INDESIT company

WT4IT

F026451

Notices

FIG. 1

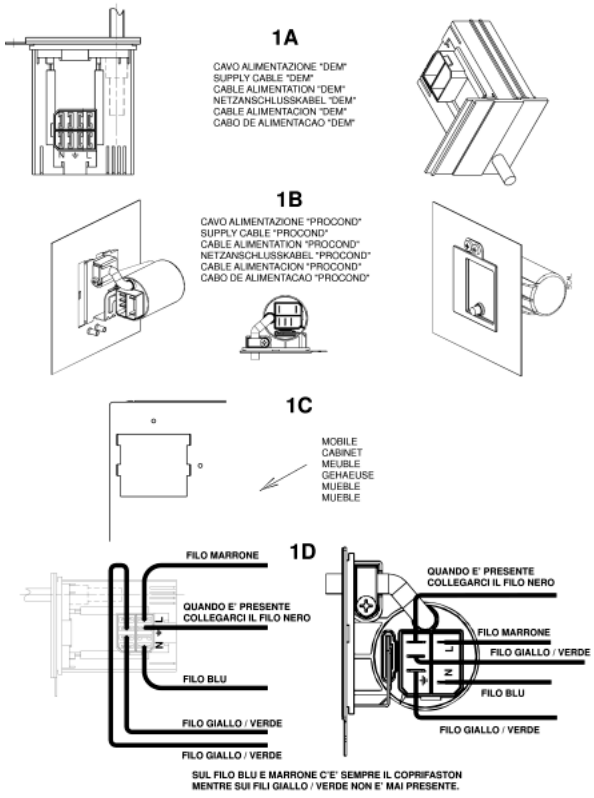
To use premodified wirings on modified products perform the connection to the terminal block of the new cable as shown in fig. 1 - 1D.
The wiring diagrams indicated in the Documentation remain the same.

From serial number 30224.0001, all top-load washing machines produced in the Brembate factory have been equipped with a new power supply cable with moulded filter and new rear panels with a specific opening for fixing the new cable.

The new power supply cables are:
Sat code 091632 Power supply cable 3x1 schuko 1.5m+capacitance filter;

N1040309FIG1

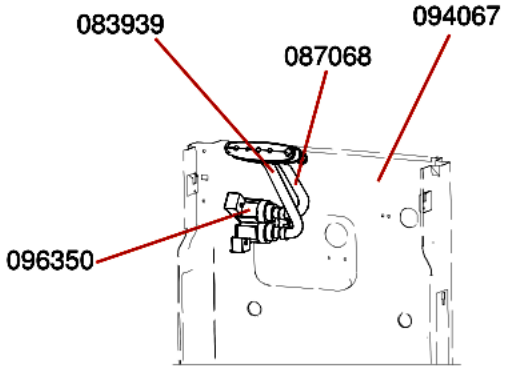
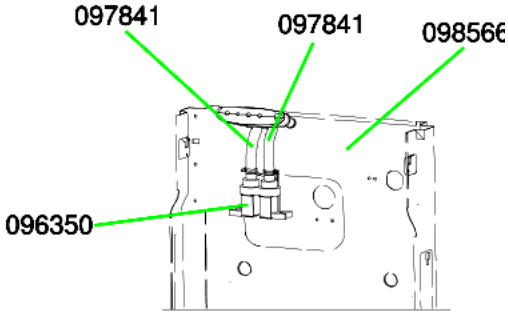
From serial no. 30912.0001, the system used for fixing the loading solenoid valve (spare part code 096350) to the rear panel has been modified on Top Loading washing machines, rotating its position by 90°.
The solenoid valve (spare part code 096350) has been modified with the 45° rotation of a coil; the Replacements Warehouse will continue to manage this part with the same code. When replacing on premodification machines, fit the coils as shown in figure N1040309FIG3-1 and on modified machines, as shown in figure N1040309FIG3-2; to rotate the coil, lift it using a screwdriver and then refit according to the inserts on the plastic.

Replacement codes of the parts affected by this modification (see figure N1040309FIG1):

FIG1 A - PREMODIFICATION STRUCTURE
solenoid valve tube/distributor assembly: premodification 083939;
solenoid valve tube/distributor assembly: premodification 087068;
rear panel: premodification 094067.
FIG1 B - NEW STRUCTURE
solenoid valve tube/distributor assembly: new 097841;
solenoid valve tube/distributor assembly: new 097841;
rear panel: new 098566.

Premodification panels will be managed by the Replacements Warehouse while stocks last; when replacing with new ones on premodification appliances the new tubes must also also be used.
When using the new panels on appliances before serial no. 30609.0001, fitted with solenoid valve code 083940, rotate the coil 45° and follow the instructions given above for code 096350, paying attention during the wiring phase to keep the cables away from the bowl support spring.

N1040309FIG2

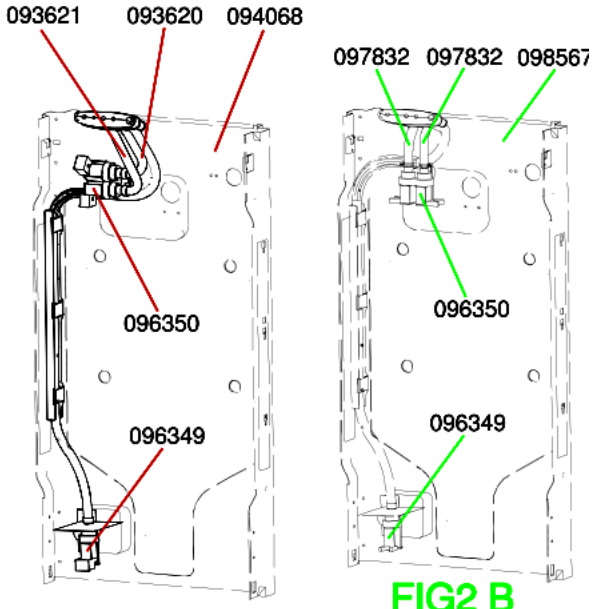
Replacement codes of the parts affected by the modification to WMTL80UK (see figure N1040309FIG2):

FIG2 A - PREMODIFICATION STRUCTURE
solenoid valve tube/distributor assembly: premodification 093620;
solenoid valve tube/distributor assembly: premodification 093621;
rear panel: premodification 094068.
FIG2 B - NEW STRUCTURE
solenoid valve tube/distributor assembly: new 097832;
solenoid valve tube/distributor assembly: new 097832;
rear panel: new 098567.

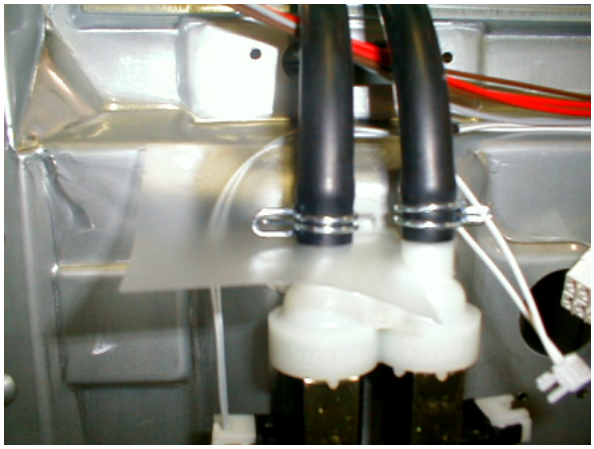
have been equipped with a plastic protection Service code 109798 (shown in N1040321FIG1), to prevent water from damaging the solenoid valve and electronic card.

N1040324FIG1

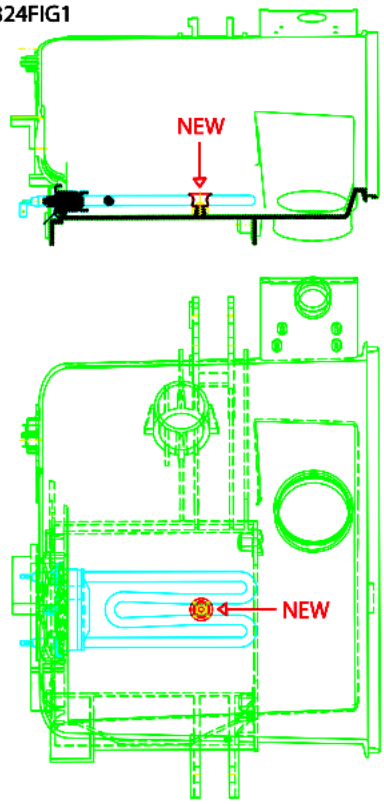
From serial number 40506.0001, the fixing system of the heater to the tank has been modified on all top-load washing machines affected by this note, with the introduction of a metal retainer (image N1040322FIG1 reference NEW) in place of deflector Service code 055322.

The modification has involved both heater and tanks. Given below are the Service codes of the new and old items concerned:

-PLASTIC TANK FOR 600-1000 RPM MACHINES: new 110152, premodification 083805;

-PLASTIC TANK FOR 1200 RPM MACHINES: new 110153, premodification 092023;

-HEATER: new 110148, premodification 083906.
